Access Compliance Report
Public Rights-of-Way
(Curb Ramps)

Intersection ID: 11414 **Main Street:** LIBETH_ST **Cross Street:** SHAMROCK_DR **Location:** SW

ADA ID: 21292B5031A2 **Ramp Type:** BlendTrans2 **Initial Pass/Fail:** Fail **Overall Compliance:** No **Severity Score:** 10

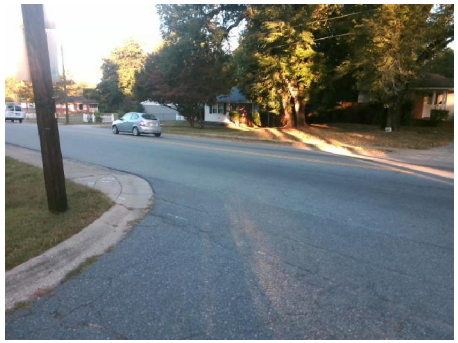
Not Found, R304.5.1

Remove & Replace Curb Ramp With Two New Directional Ramps or Equivalent.
